Re: 46 Sconticut Neck Road (Residence by Girls Creek)

**GCG ASSOCIATES, INC.**

February 16, 2021

Re: Residence by the Girls Creek  
Definitive Subdivision Plan, 46 Sconticut Neck Road, Fairhaven, MA.

Plan Sheet 10 – Infiltration Basin, Cross Section and Details.

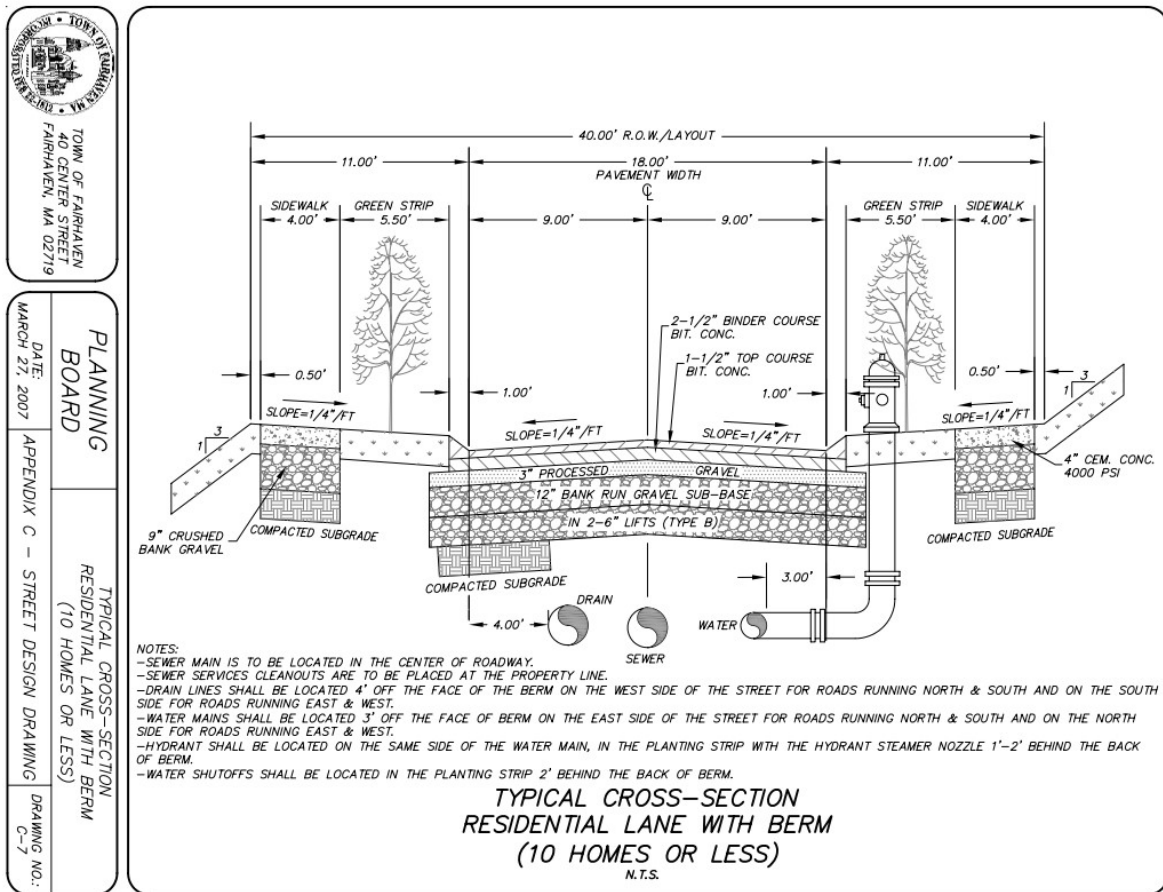
4. Provide outlet control structure details, (specify precast DMH structure, diameter, opening dimensions, etc.) and (frame and grate make and model number). A standard 36" x 36" heavy duty grate weight 554 pounds per East Jordan Iron Works, could be difficult for DPW maintenance personal to handle as shown. GCG recommends utilizing grate(s) with manageable weight without heavy equipment.

5. Emergency spillway/weir side slope should be 3H:1V minimum.

Sufficient detail and information is provided in the plans and details. Vehicular access path is provided for any machinery that may be necessary in handling the structure and cover.

Revised as requested.
